**UNITED STATES DEPARTMENT OF COMMERCE
Patent and Trademark Office**

09/476,521 01/03/00 GROPP

Office Action Summary

Applicant(s)
GROPP et al.

Fig. 1

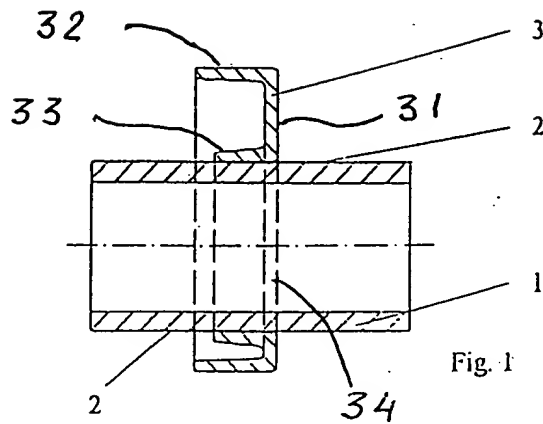
(C) The corrected Fig. 1 has been approved.

10. The original drawings are objected to because: (a) the drawings should show the plane upon which a sectional view such as Fig. 1 is taken; and (b) each part of the invention such as the solid rod in claim 15 should be designated by a referential numeral or character. Correction is required.

Fig. 2

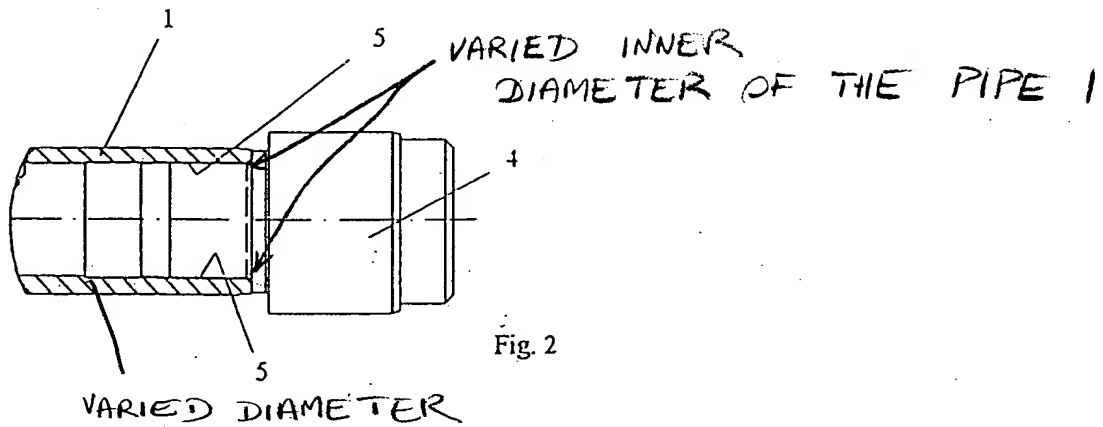
(a) new Fig. 4 introduces new matter such as the end piece 4 as now shown. The original Fig. 2 shows that the inner diameter of the pipe 1 is varied: (1) at the junction of the end piece 4 and the pipe 1 as shown by applicant's phantom line; and (2) at referential numeral 1 (see attached Exhibit). However, Fig. 4 shows that the inner diameter of the pipe 1 is constant. The original disclosure does not convey the concept that the inner diameter of the pipe 1 is constant, thus, it is unsupported by the record as filed. *In re Anderson*, 176 U.S.P.Q. 331 (CCPA 1973); and

Not
Approved
VL
10/20/00

Fig. 3

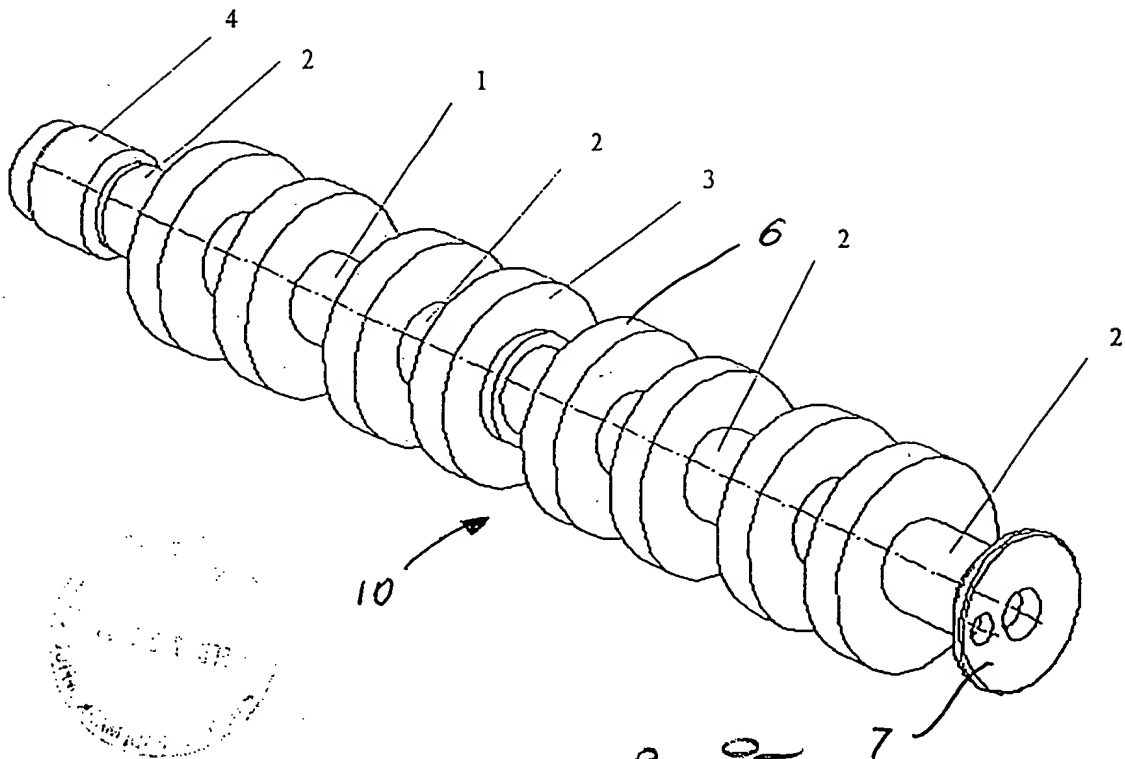
(B) The corrected Fig. 3 has been disapproved since it introduces new matter. The original drawings do not show the bearing rings. The corrected Fig. 3 now shows the bearing 6 which is identical to the cam 3. The showing and description of a specific type of bearing within a full spectrum of possible bearings is considered under the present disclosure to be new matter. *Cf.*, *In re Smith*, 173 U.S.P.Q. 679 (CCPA 1972) and *Ex parte George*, 230 U.S.P.Q. 575, 578 (Bd. Pat. App. & Inter. 1986).

(C) the insertions in lines 13 and 14 on page 6 of the specification. The original drawings do not show the bearing rings. The corrected Fig. 3 now shows the bearing 6 which is

identical to the cam 3. The showing and description of a specific type of bearing within a full spectrum of possible bearings is considered under the present disclosure to be new matter. *Cf., In re Smith*, 173 U.S.P.Q. 679 (CCPA 1972) and *Ex parte George*, 230 U.S.P.Q. 575, 578 (Bd. Pat. App. & Inter. 1986).

Fig. 4
CONSTANT
DIAMETER
(NEW MATTER)

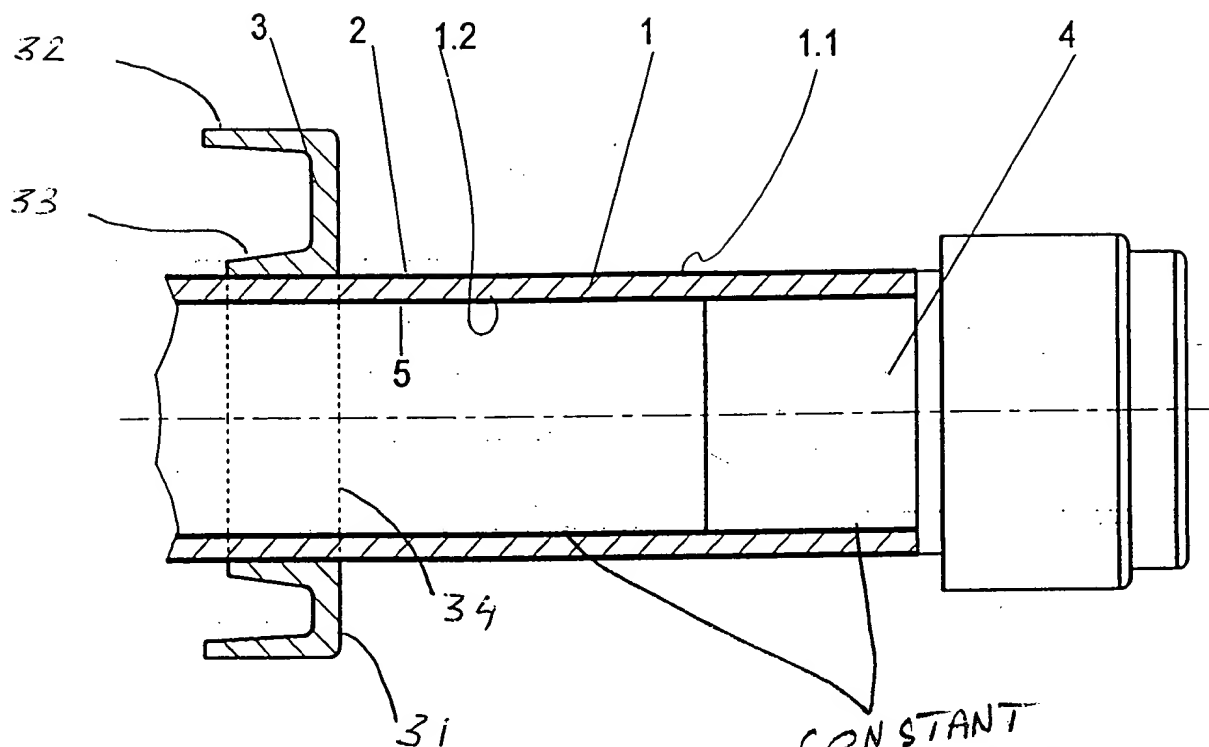
(A) New Fig. 4 has been disapproved because:

(b) new Fig. 4 is inconsistent with the description in Paper No. 9. The insertion on page 6, line 12 of the specification, states that the outer diameter of the end piece 4 is slightly larger than an inner diameter of the pipe 1. However, Fig. 4 shows that the outer diameter of the end piece 4 is equal to the inner diameter of the pipe 1.

Disapproved
VL
10/20/00
